DEVELOPMENT REVIEW BOARD
SUPPLEMENTAL SUBMITTAL

PROJECT NO. PR-2020-004820

To: Jolene Wolfley and DRB Members, City of Albuquerque
From: Michael Vos, AICP, Consensus Planning, Inc.
Date: April 15, 2021
Re: Hotel Circle Ramada Apartment Conversion DRB Update (PR-2020-004820)

This memo provides updates on the proposed apartment conversion based on the comments received at the March 31, 2021 DRB meeting. The comments are numbered, and responses are in bold italics.

A1 FIRE ONE PLAN
1" = 40'-0"

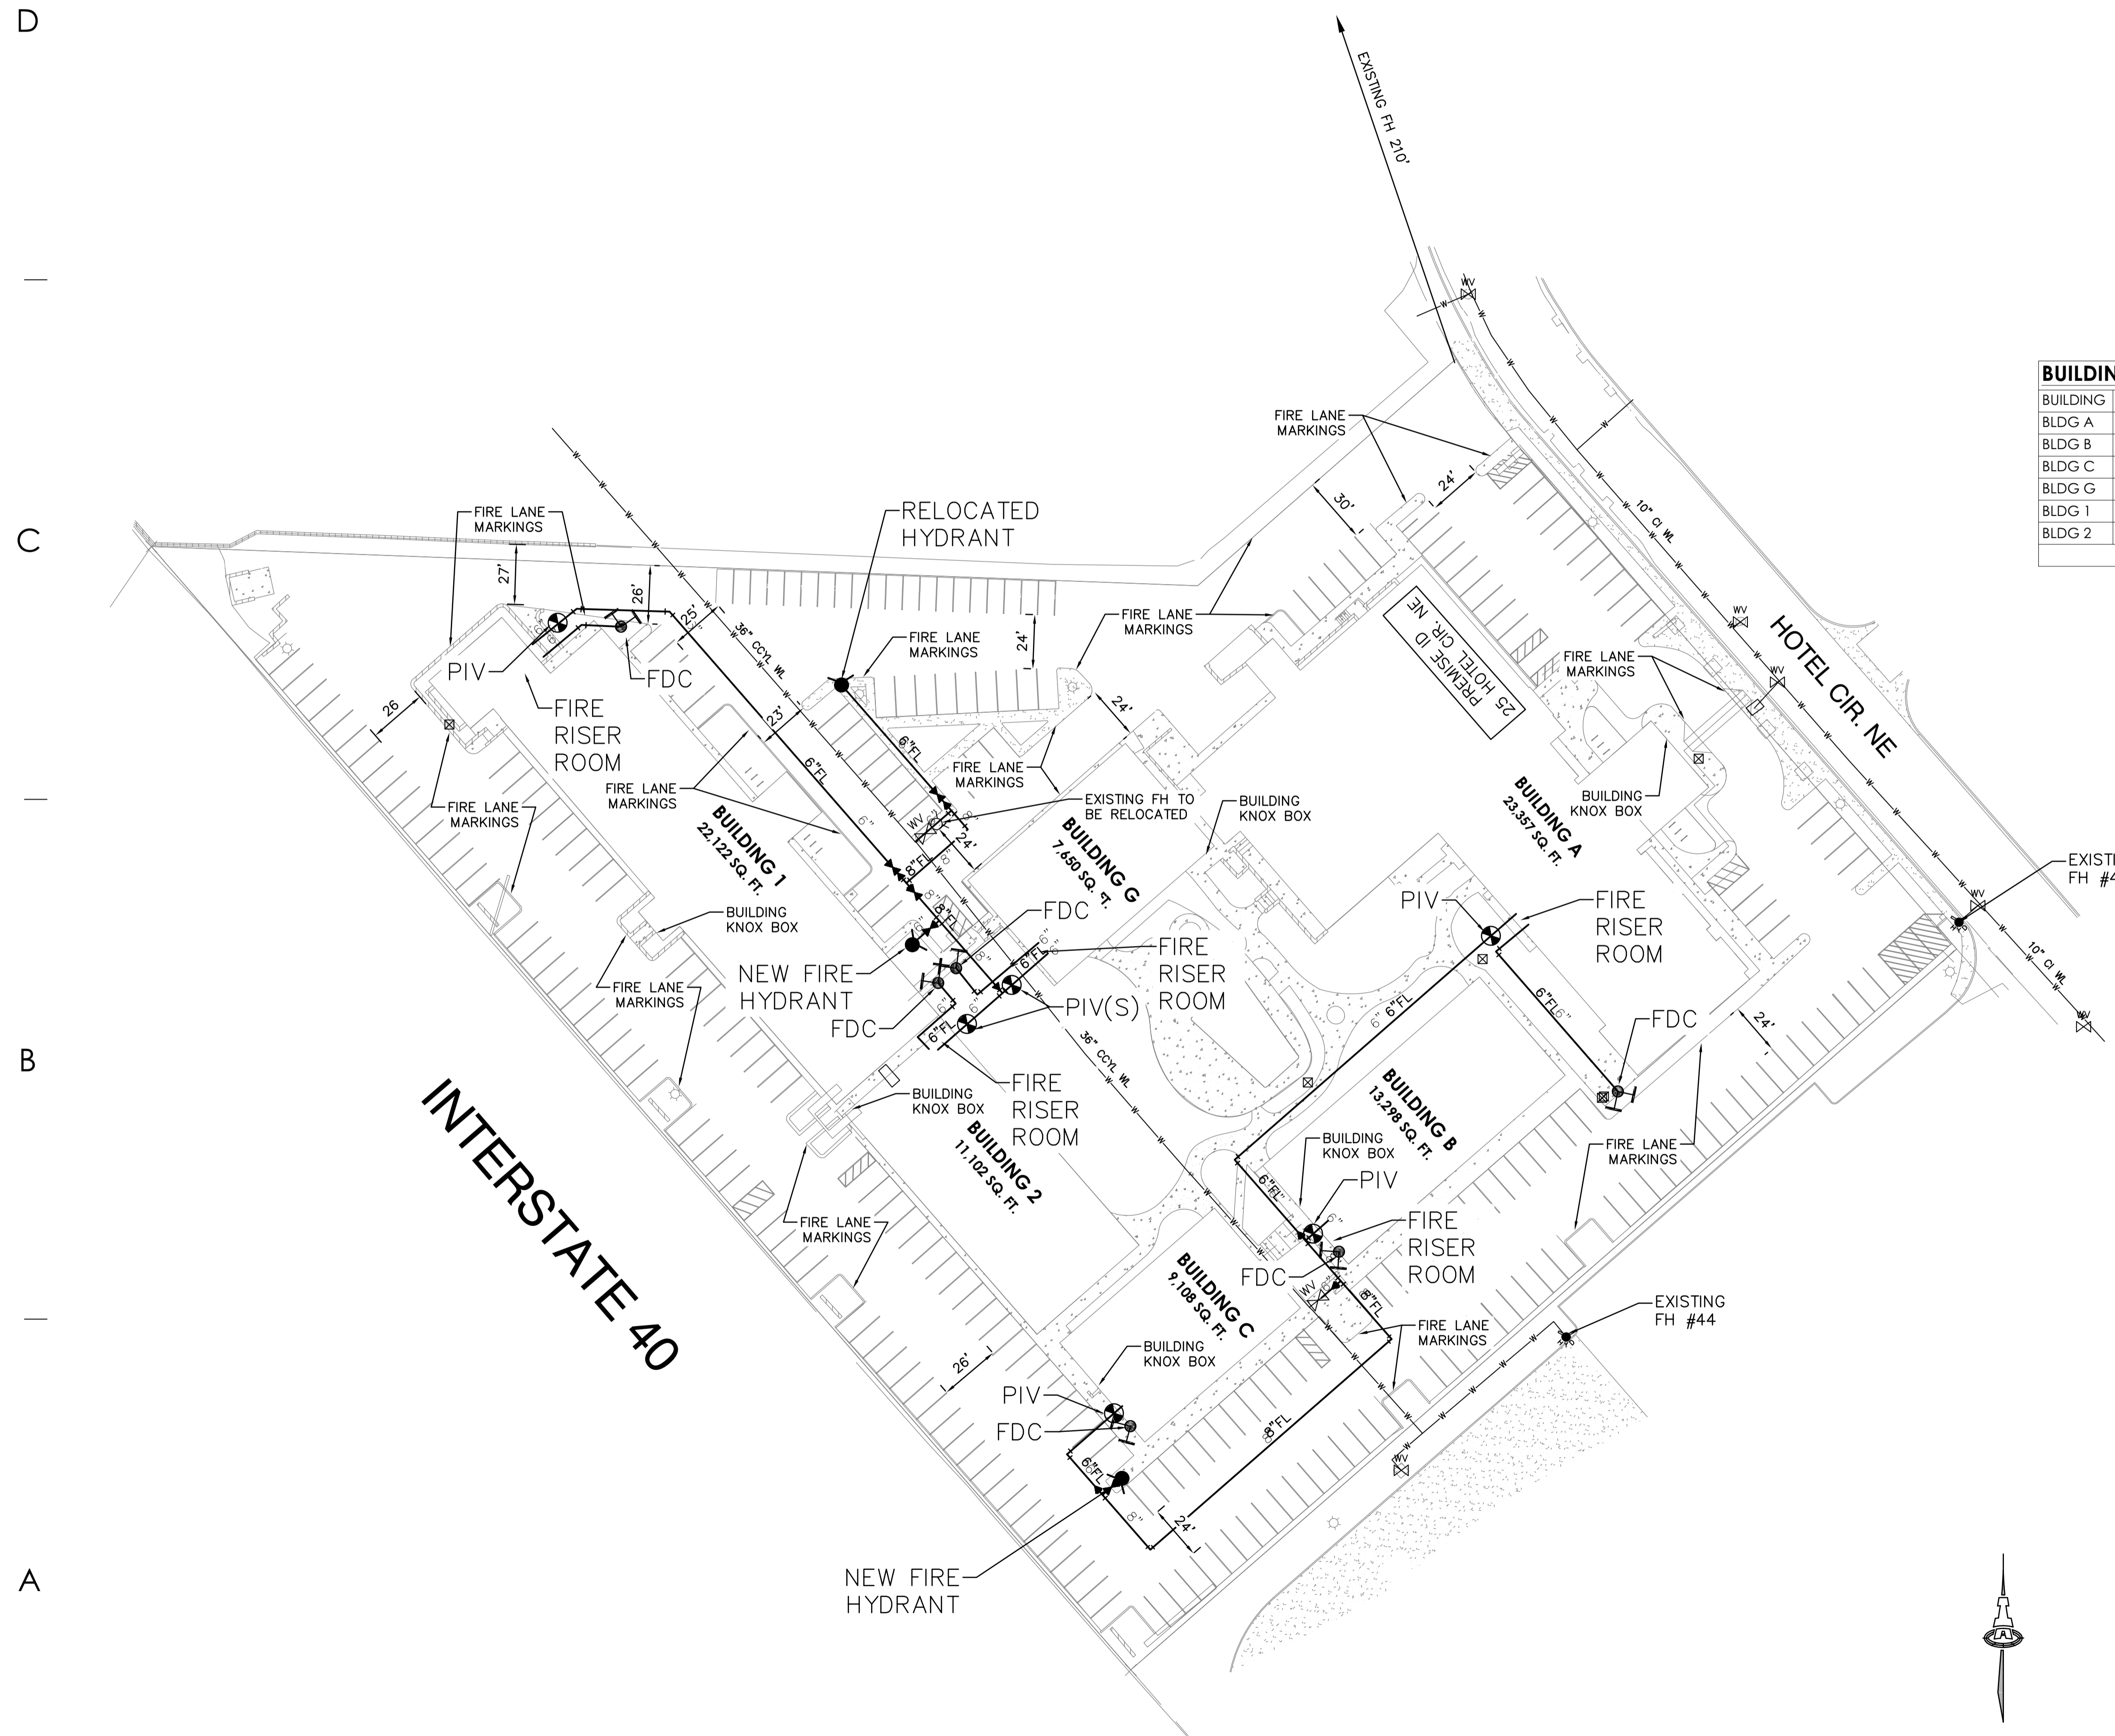
1. PREVIOUS COMMENT: Availability statement #201213 is in holding as a fire one plan is required. UPDATE: The fire one plan has been received with this submittal and has been provided for inclusion in the availability statement review.
 - a. We understand that the availability statement has been researched and is under review.**
